Dear referees,

Responses to Referee Ruben Imhoff

As suggested by referee, we changed the title to 'Space variability impacts on hydrological responses of Nature-Based Solutions and the resulting uncertainty: case study of Guyancourt (France)'

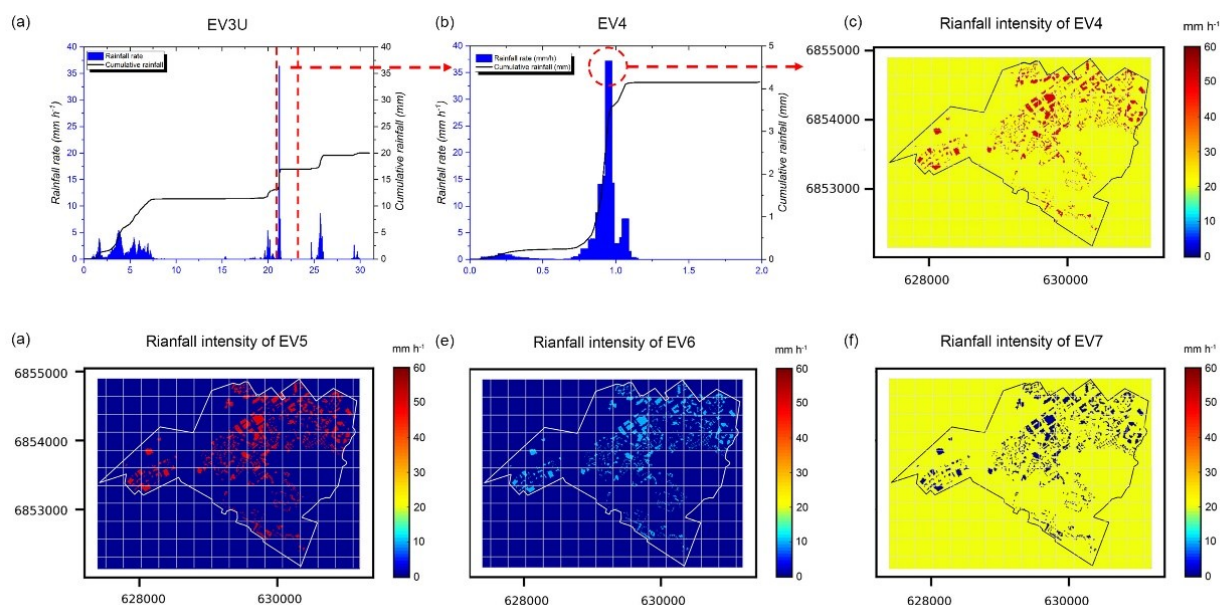
I think the authors chose for an elegant application by using the multifractal approach. The authors write: “For instance, both ‘hot spots’ (extremes) of the rainfall and NBS are scarce and therefore could rarely coincide, i.e., rainfall spikes may fall more often elsewhere than on NBS. Similar questions can occur for less extreme events. The effective NBS performance could be therefore biased with respect to their potential performance due to this problem of intersection between rainfall intensity and NBS”. This make me wonder if a synthetic experiment would have worked too. In such an experiment, you can exactly define where, how much and when the rainfall falls and the same for the location and density of the NBS applications. This would make it possible to do a larger sample analysis of the effects (the authors point on the need for this in the conclusion). Could the authors comment on this and if they agree that something like that – or another approach – is possible, write something about it in the discussion?

Thanks to the referee’s suggestion, we designed a synthetic experiment with the help of four synthetic rainfall events (EV4-EV7) and GR scenarios (GR1 and GR2). We added the description of the synthetic experiment and the corresponding results and discussions in our revised manuscript.

To deepen the understanding of the intersection effects between the spatial variability of rainfall and spatial distribution of NBS, we also considered 4 synthetic rain events (EV4-EV7). All these events are based on the uniform rainfall of EV3U, by selecting the 2 hours period with the highest rainfall peak around 35 mm h⁻¹ (space average), as illustrated on Figure 1A (a). However, during the 3 min that lasted the largest rainfall peak of the EV3U, a new space distribution and/or intensity of the rainfall was imposed for each synthetic rainfall event. As shown in Figure 1A (b), the areal averaged maximum rainfall peak is about 37 mm h⁻¹ for the EV4, and the corresponding areal averaged cumulative rainfall is about 4 mm. During these 3 minutes, the rainfall was binary re-distributed in space (Figure 1A (c)), with the maximum intensity around 55 mm h⁻¹. For the remaining synthetic rain events this binary distribution was modified as follows (see Figure 1A (d-f)): the same maximum intensity of 55 mm h⁻¹ and zero rainfall elsewhere (EV5), the maximum intensity of 17 mm h⁻¹ and zero rainfall elsewhere (EV6), and the maximum intensity of 55 mm h⁻¹ has been replaced by zero rainfall (EV7).

Here, the GR1 scenario was taken as the reference scenario, we assume that the extremes of rainfall (hot spots) only falls on the green roofs of the GR1 scenario. With this respect, we binary re-distributed the rainfall in space during the 3 min that lasted the largest rainfall peak of the EV3U, as illustrated on Figure 1A (c-f). Namely, the ‘hot spots’ of the EV4-EV6 synthetic rain events are strictly intersected with the GR1 distribution, while the GR2 scenario is not. Contrary to EV4-EV6, EV7 corresponds to the ‘no rain’ situation on GR1 during the same 3 min.

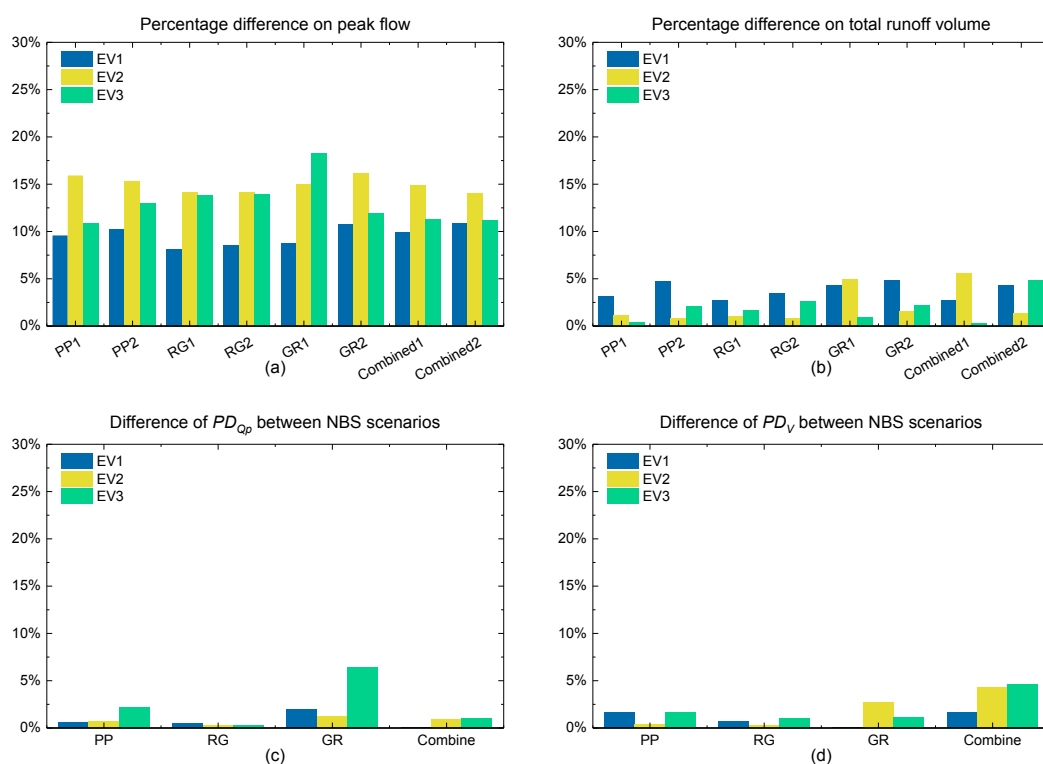
Page 14, lines 433 – 437: I think this is one of the most interesting (and important) results of the study. However, it is not very easy for the reader to make the comparison based on the figures (e.g. figures 14 and 16). Could the authors add a subplot to figure16 indicating the differences between the two scenarios (so the difference between uniform and non-uniform rainfall plus the difference between the scenarios) and tell somewhat more about it?

Figure 14: I spotted a minor typo in the figure title (Percenatge instead of percentage).

The resulting uncertainty on the peak flow and total runoff volume (PD_{Qp} and PD_V) of the third set of modelling experiments are shown in Figure 16. Firstly, we found that the spatial variability of rainfall has a certain extent impact on the peak flow of each scenario, with the PD_{Qp} ranging from about 8 % to 18 %. With the exception of GR1, all the NBS scenarios have a similar tendency: the PD_{Qp} are the lowest for the first event, and the highest for the second one. Namely, for most of NBS scenarios, the PD_{Qp} (uncertainty on peak flow) increases with the increase of the spatial variability of rainfall intensity. As shown in Figure 16c, comparing the PD_{Qp} between scenarios of PP1 and PP2, RG1 and RG2, as well as Combined1 and Combined2 for the three rainfall events, the maximum difference is less than 3 %. However, comparing the PD_{Qp} between GR1 and GR2, the difference is larger, especially in EV3 (> 6 %). For the GR1 scenario, PD_{Qp} range from about 8.7 % to 18 % in all three rainfall events, and those of GR2 range from about 10.7 % to 16 %. Furthermore, for GR1, the largest PD_{Qp} is in EV3, but for GR2, the largest PD_{Qp} is computed for EV2. The difference of PD_{Qp} between GR1 and GR2 scenarios demonstrated that the spatial variability of rainfall and the spatial arrangement of GR measures have some intersection effects on the peak flow of GR scenarios. However, it is not evident for the other NBS scenarios. One of the reasons has been discussed in Sect. 4.1.2: in the GR1 scenario, GR measures are mainly implemented in the north part of the catchment, which coincidentally received lower rainfall (distributed EV3); namely, the "hot spots" of the rainfall field were scarcely intersected by the GR measures due to their low fractal dimension. Another possible reason is GR has the lowest storage capacity in the studied NBS, as well as the studied rainfall events are not intense enough to saturate the other types of NBS (see Versini et al. (2016) for a comparison of different properties of GR). Her et al. (2017) also indicated the hydrological performances of NBS are sensitive to their configurations. However, the most plausible reason is that the intersection effect is more perceptible for GRs, as they only respond to local precipitation, while it is often masked for other NBS measures that must also mitigate runoff received from other parts of the watershed. Indeed, the already mentioned integrative character of runoff should reduce the evidence for intersection effects in other NBS scenarios, whether for gridded or uniform rainfall.

As referee suggested, we add a subplot to Figure 16. The corresponding figures and discussions can be found in the answer for **2.5 The results in a larger perspective.**

Thanks to the referee's suggestion. The misspelling was revised for the corresponding Figure 16.

Figure 2: Left: land use map (baseline scenario). Right: drainage system with four conduits (4541, 4542, 4543, and 4544) highlighted.

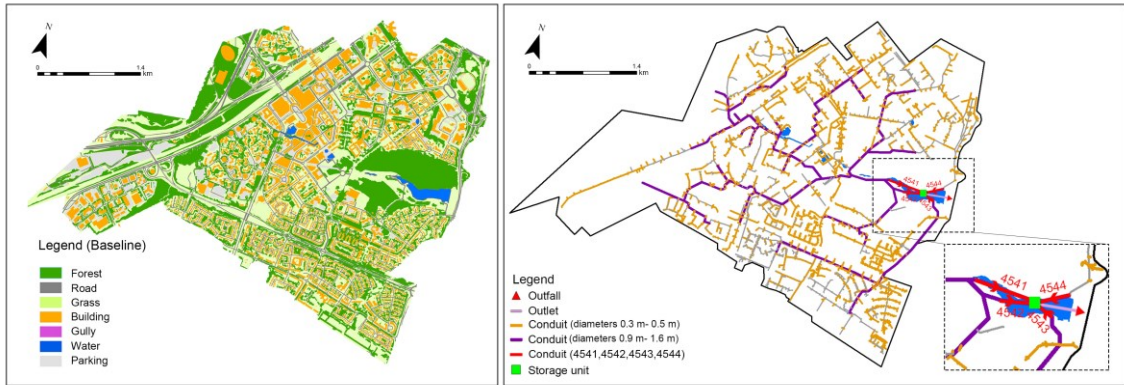
Figure 2: I may be wrong, but it seems that the legend colour for forest is not exactly the same as the colour used in the map. Figure 3: The rainbow colour map is not always intuitive, also here with respect to the rainfall amounts. I recommend using a more intuitive colour map. Some explanations and inspiration can be found in Crameri et al. (2020).

Thanks to your suggestion and reference. The legend colour for the forest was changed in the map (Figure 2). The rainbow colour map was changed for Figure 3

Figure 10: Simulated flow ($m^3 s^{-1}$) of the baseline scenario under three distributed rainfall events and three uniform rainfall events: (a) EV1, (b) EV2, (c) EV3.

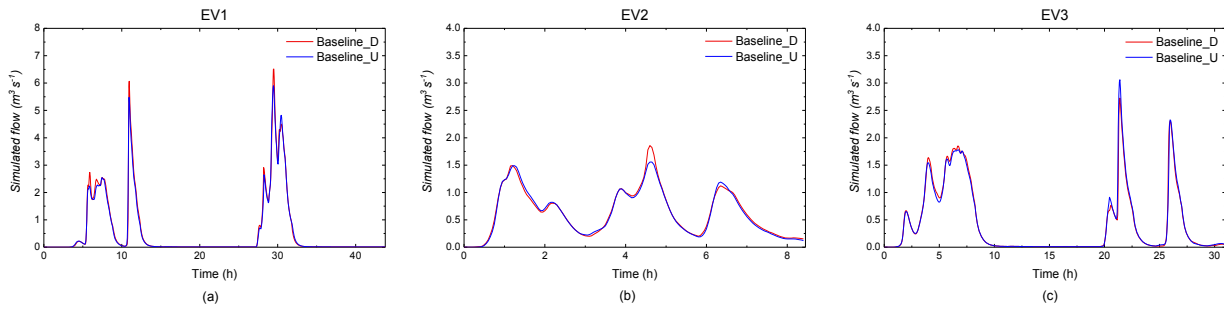
Figure 10: The authors refer in the caption to (a) EV1, (b) EV2, (c) EV3, but the letters (a) – (c) are not shown in the figure.

Thanks to your suggestion. The letters (a) – (c) were added in the revised map.

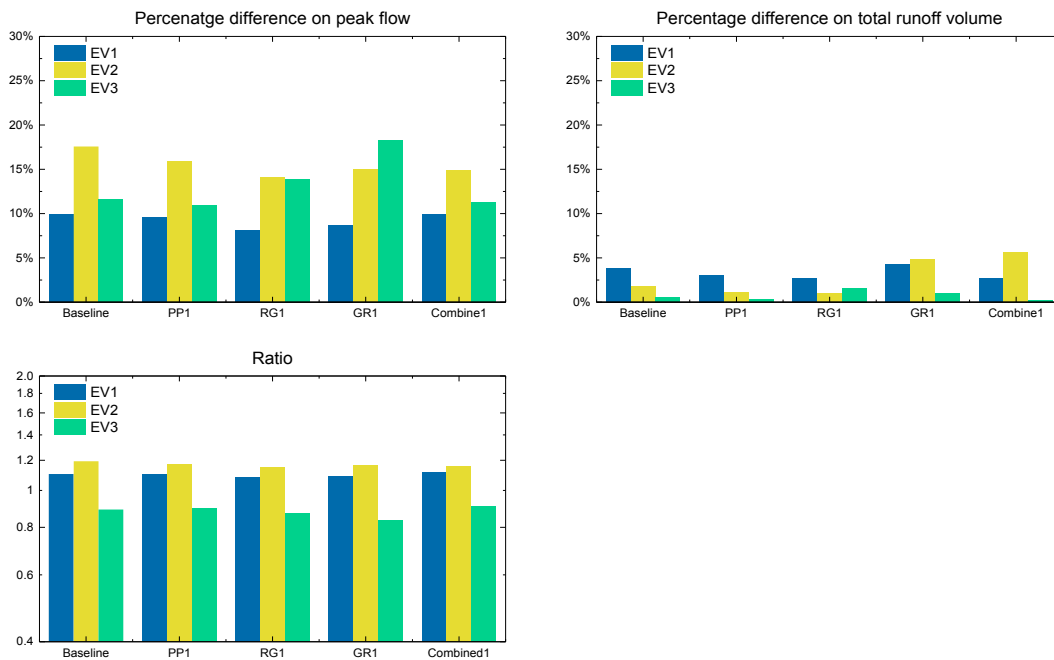
Figure 12c: It would be better to show the ratio on a logarithmic axis.

Thanks to your suggestion. The ratio of peak flow between the scenarios under the distributed rainfall and the scenarios under the uniform rainfall was plotted on a logarithmic axis in the revised manuscript.
